RE: JMC Project 20101  
 The Summit Club at Armonk  
 568 & 570 Bedford Road (NY 22)  
 Town of North Castle, NY

**Response to Town Comments Resubmission (Golf Course-Maintenance Building)**

The revisions depicted on the above noted plans reflect responses to comments outlined in the Town of North Castle Planning Department Memorandum, dated 03/18/2024 and Planning Department email correspondence, dated 04/11/2024. For ease of review, we have repeated and enumerated the comments in italic print, followed by our responses:

**SITE LAYOUT PLAN**

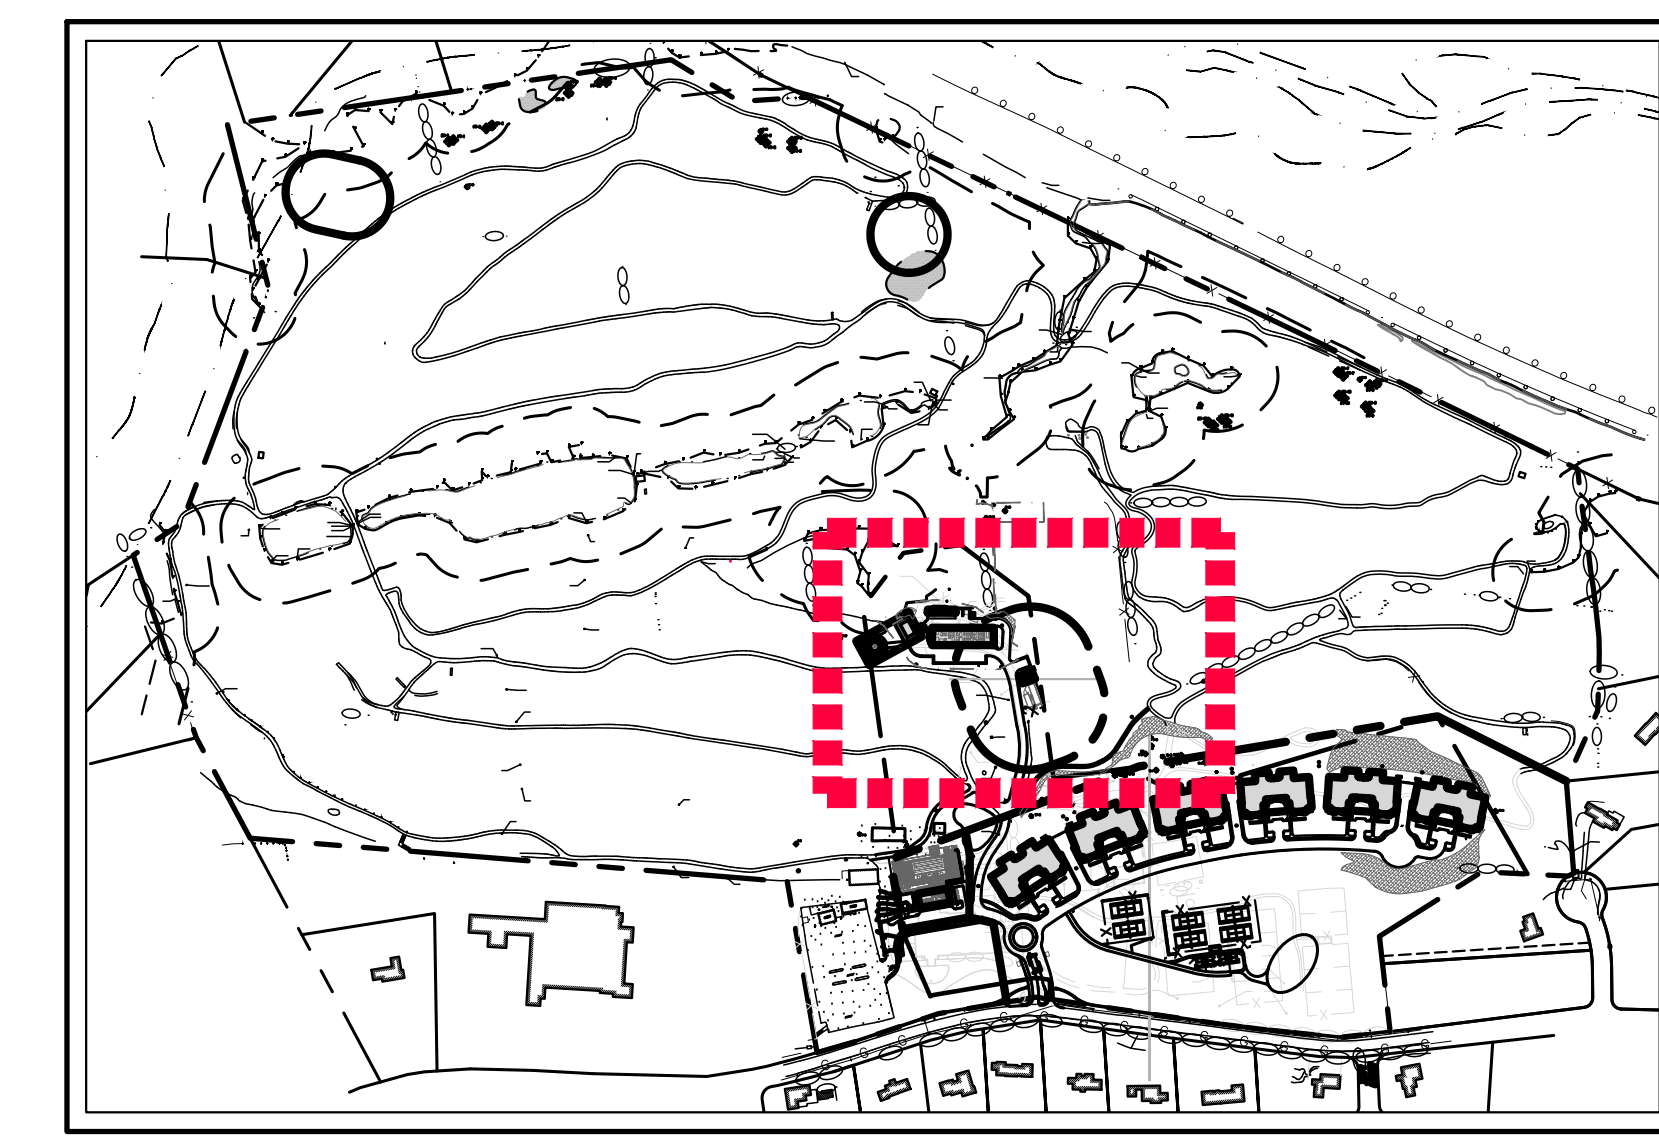
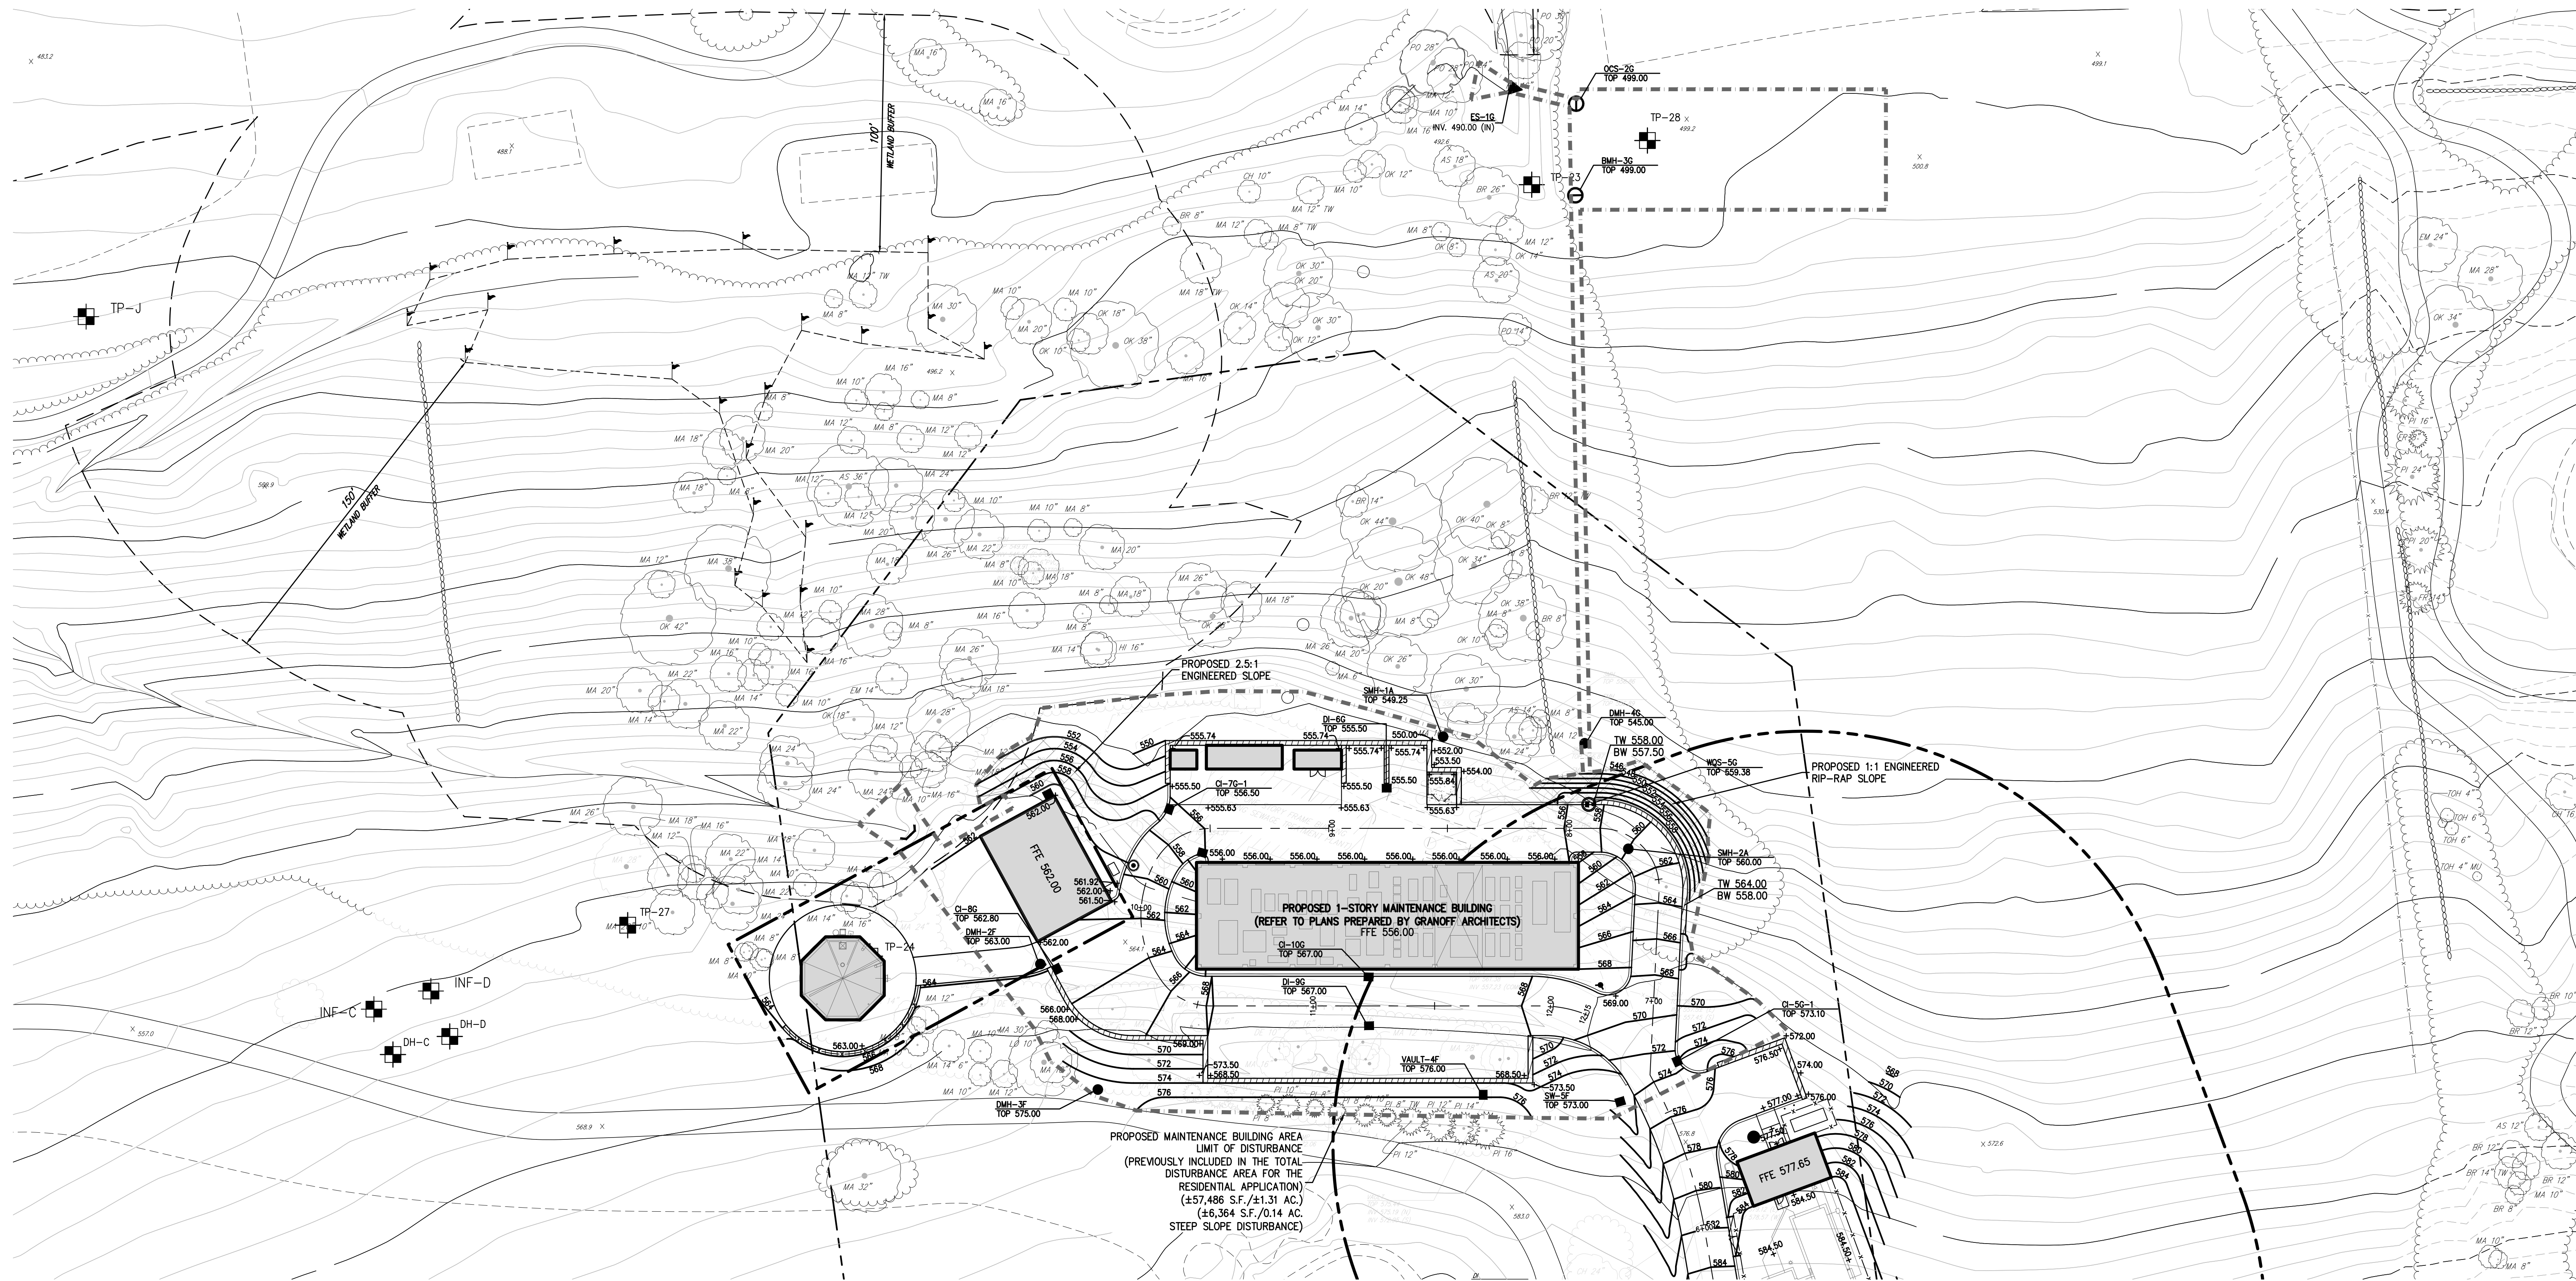
*The site plan notes that a fueling station is proposed. Staff was not able to discern the location of the fueling station, details or how much fuel is proposed to be stored. Additional information should be submitted to the Planning Board. The Applicant should also demonstrate that the proposed fuel storage is adequately isolated from the proposed chemical storage.*

The plan has been revised to indicate the location of the proposed ConVault split fuel tank – 500 gallon diesel, 1,500 gallon gasoline tank. Refer to Drawing C-101M prepared by JMC, last revised 04/25/2024.

SUMMIT CLUB MAINTENANCE BUILDING

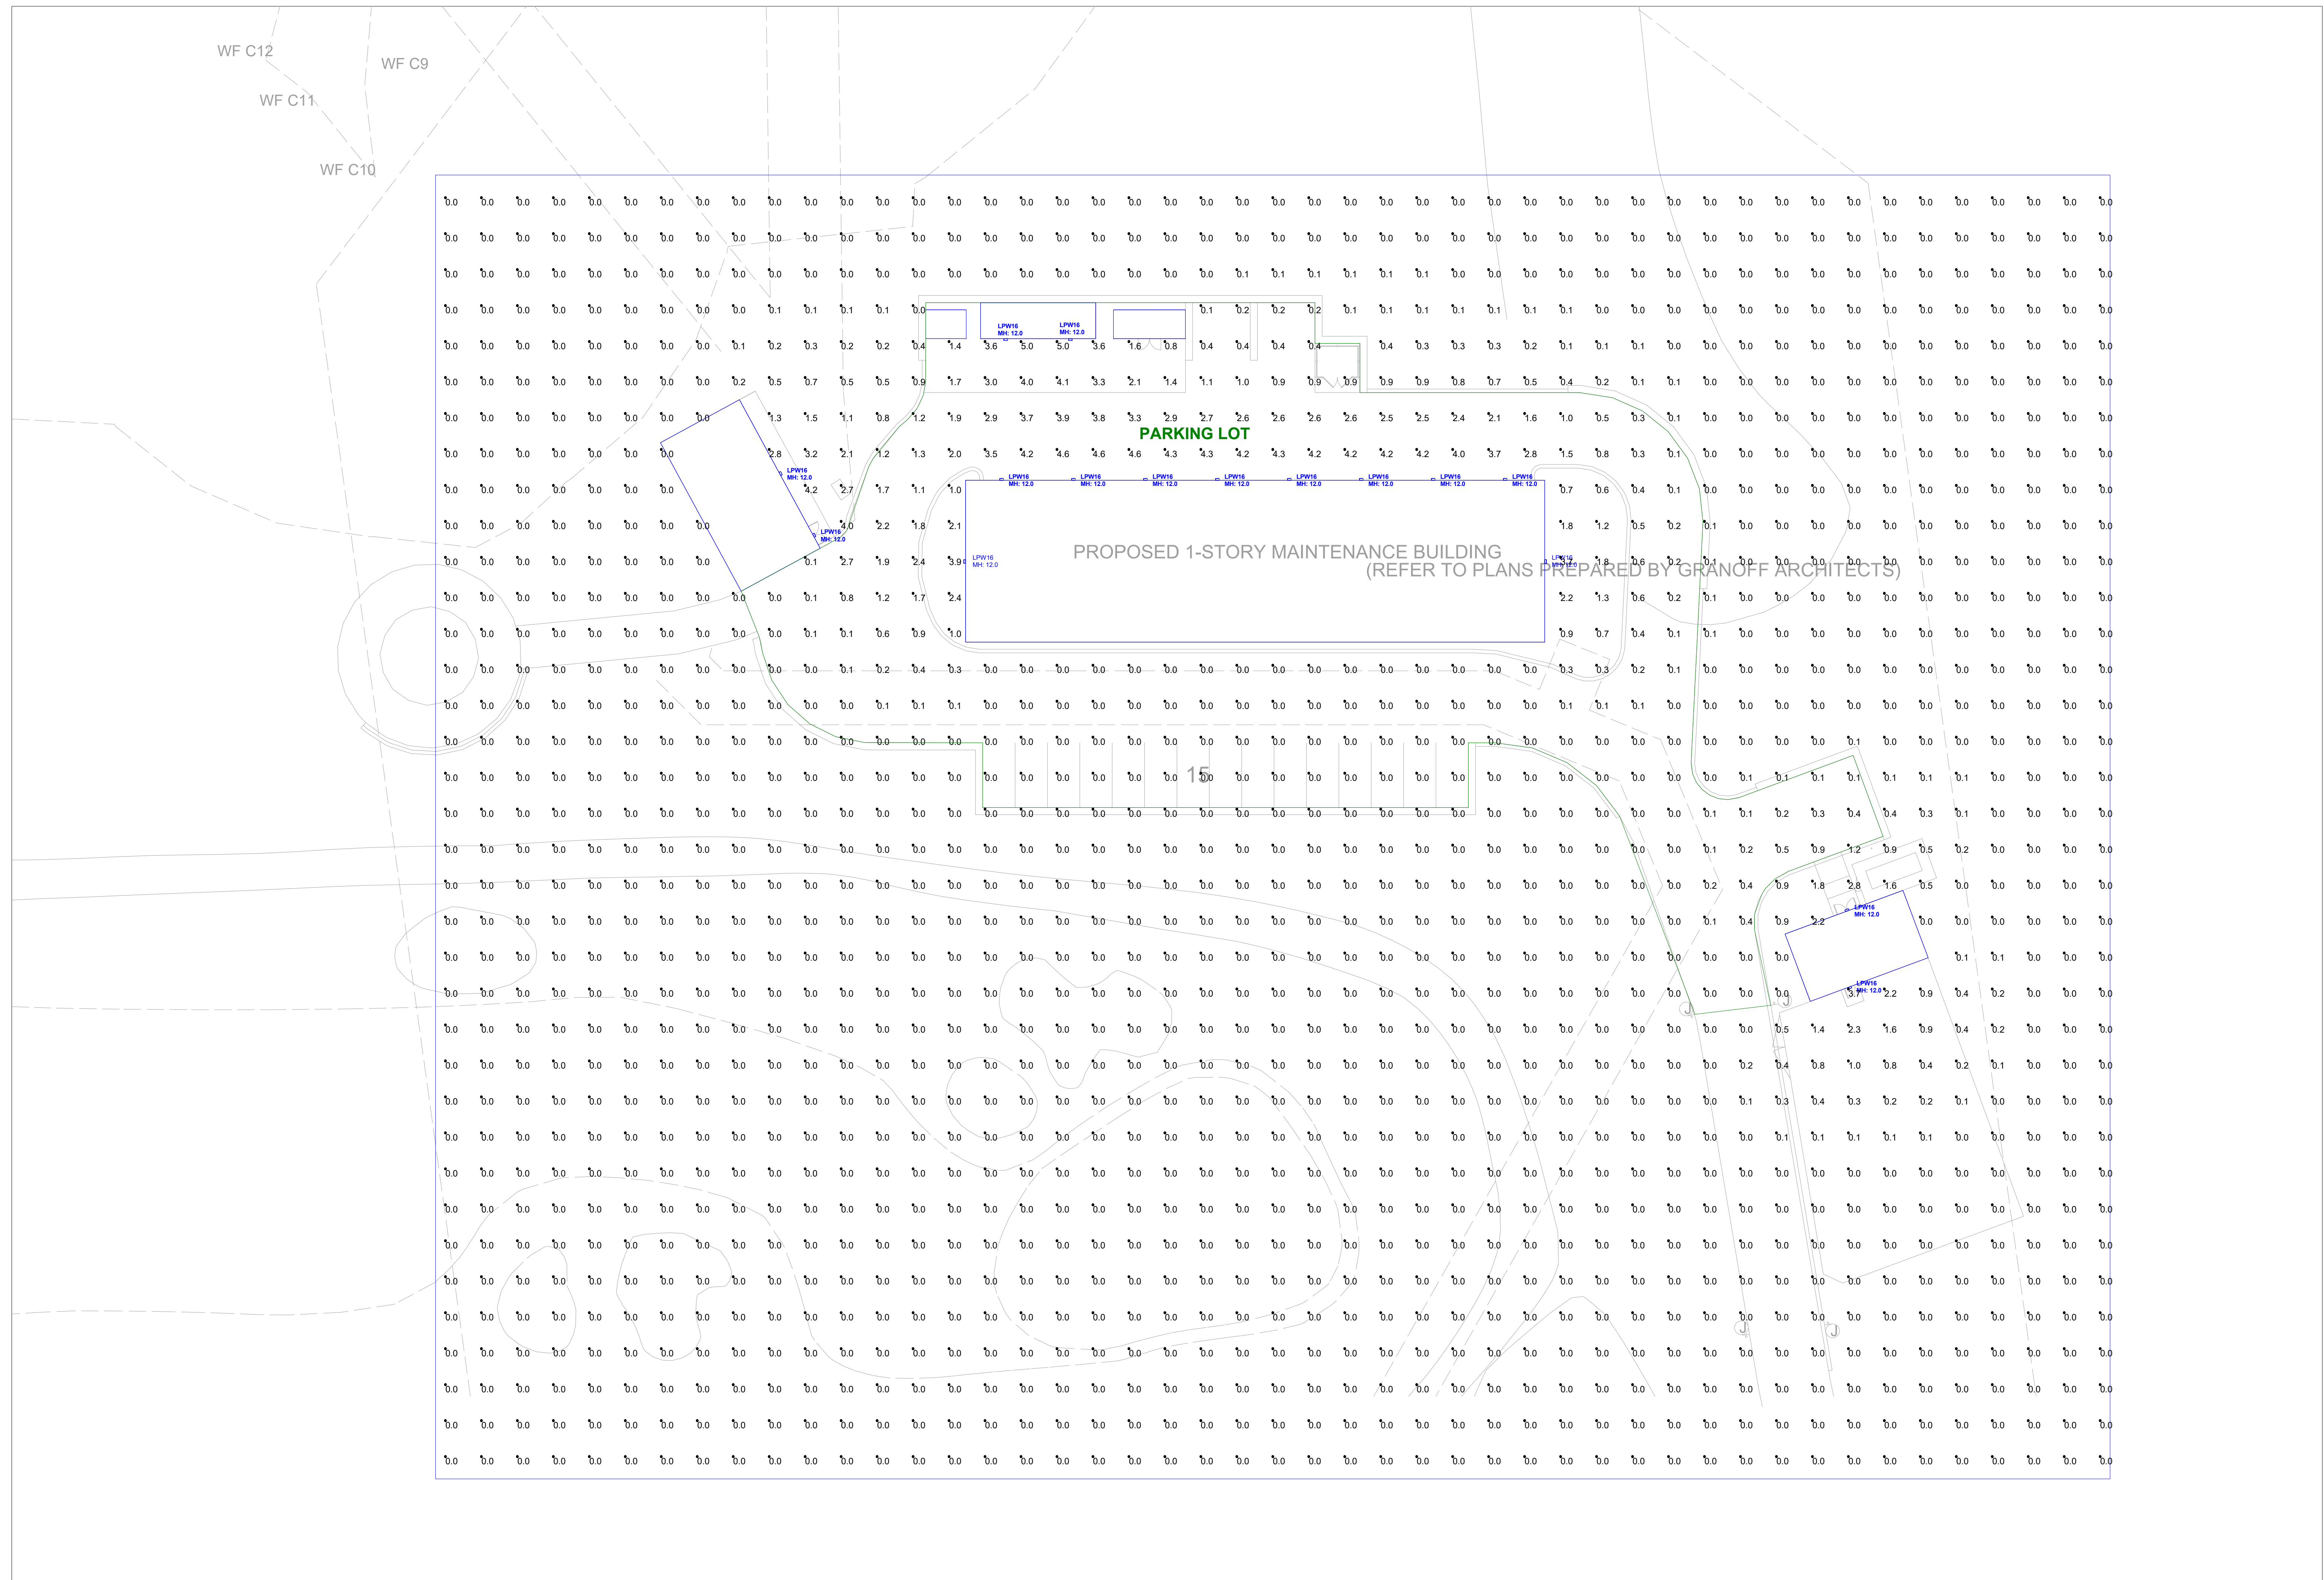
*The Applicant should submit a photometric plan for review.*

A photometric plan has been prepared. Refer to Drawing "Summit Club Maintenance Building" prepared by Apex Lighting Solutions, last revised 04/23/2024.
